APR1400 Design Certification

RAI No.: 461-8579

SRP Section: 15.06.03 - Radiological Consequences of Steam Generator Tube Failure (PWR)

Question No. 15.06.03-5

Figure 1 Primary and Secondary Pressures vs. Time

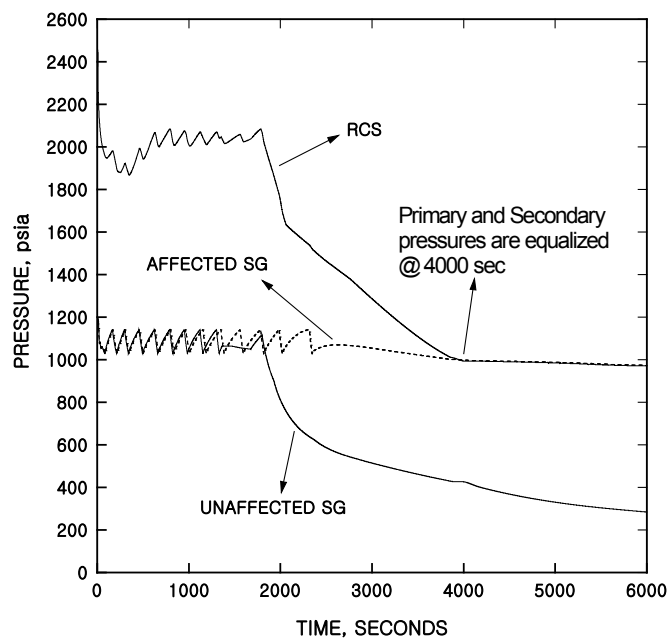
1. Extend the CESEC-III analysis of the SGTR event until acceptable analysis termination criteria are met (e.g. steam relief through affected steam generator is terminated, break flow is terminated)
2. Update Section 15.6.3 of the APR1400 DCD as appropriate.
3. Update the analysis of radiological consequences as appropriate.

As shown in the Figure 1 below, the primary and secondary pressures are same at 4,000 seconds after the event initiation. The break flow is decreased after 1,800 seconds and terminated at 4,000 seconds as shown in Figure 2. However, in terms of radiological consequences, the results in DCD conservatively assumed that the break flow rate at 1,800 seconds is maintained until that the primary and secondary pressures are equalized in the calculation of the flashed mass of break flow. The total flashed mass of break flow is assumed to be completely discharged to the environment. Therefore, DCD analysis presents a bounding case in terms of radiological consequences.
